**AGENDA
TECHNICAL REVIEW COMMITTEE (TRC)
June 6, 2023
10:00AM**

B. Lakeside Storage II – Major Site Plan (Alternate Keys: 2919469, 2919507, 2919523 & 2919531)

RE: Lakeside Storage II Major Site Plan Review #2 (Halff AVO 043866.100)

SITE PLAN

CONCEPT PLAN

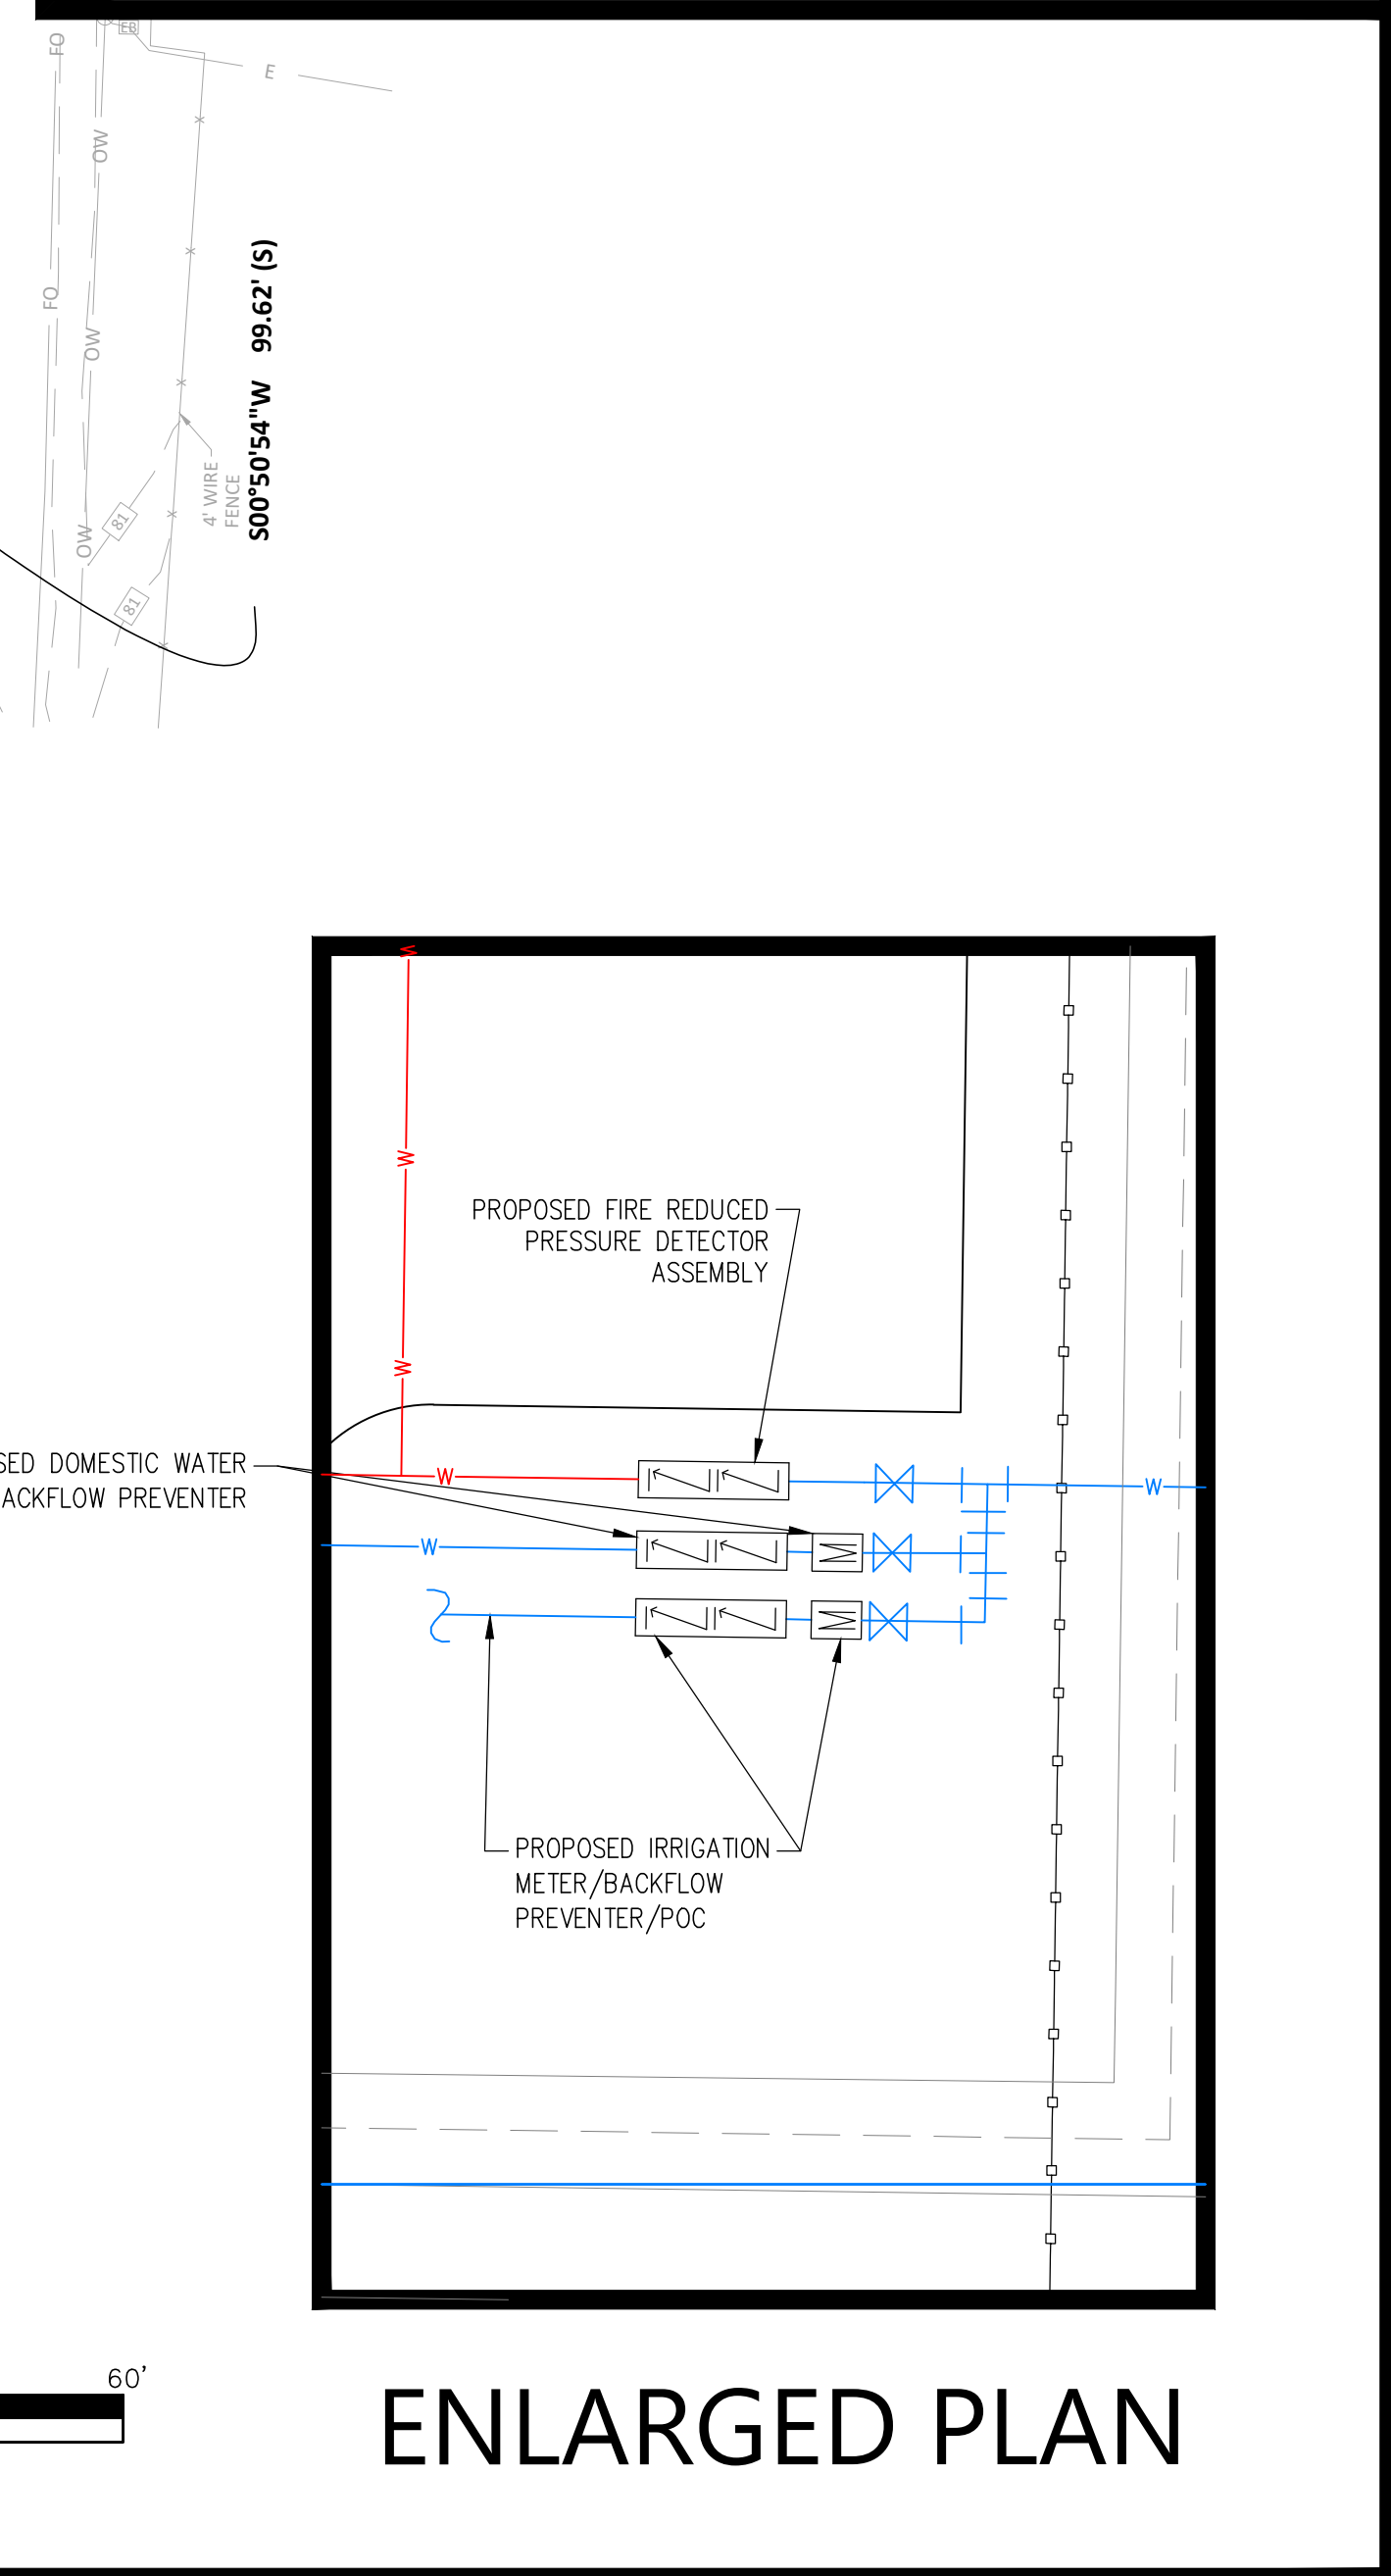
A conditional use permit approval is requested to develop a 24,000 square foot garage on the subject site. The revised conceptual site plan has addressed planning comments and meets the minimum technical standards of Chapter 155, Section 155.010(b)(1). Staff recommends the following conditions:

- 1) Storage shall be limited to personally owned vehicles.
- 2) Building Perimeter landscaping. A minimum three (3) foot wide landscape area, with an average of

five (5) feet or more, around a minimum of forty (40) percent of the total building perimeter and within twenty-five (25) feet of the building walls. Minimum planting requirement. One (1) canopy tree or three (3) understory trees, and twenty-eight (28) shrubs shall be required for every three hundred and fifty (350) square feet of planting area in (a) above. Trees installed for any other requirement of this Section may be credited towards this requirement if in the required location.

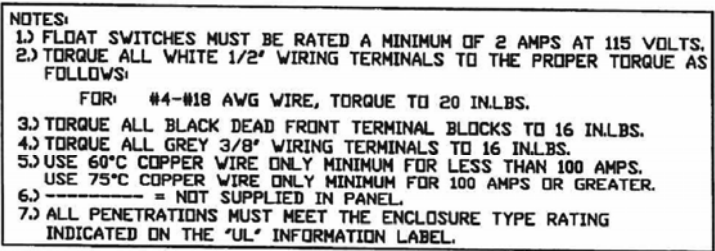
1. On sheet C6.3 – 4" diameter is called out on the Lift station section view. Please update.
2. 6" invert elevation at 2% slope for 57 LF appears to be 123.86. Please update calculations to reflect correct invert elevation and alarm elevation.
3. The design head listed on pump information table is revised but is still not correct. As per the submitted calculations, the total head should be $33 \text{ ft} + 5.75 \text{ ft} + 0.42 \text{ ft} = 39.17 \text{ ft}$. It appears that 14.3 psi is added to 5.75 ft to get 20.05 ft of static head without conversion.
4. The pump model number on pump information table does not match the submitted pump datasheet.
5. Please provide a different pump as per the design flow and design head requirement. It appears that 15 gpm at 40.0' of head is not in this pump's operational range.
6. Please provide waiver for the fire hydrant on an 8" main upon approval.
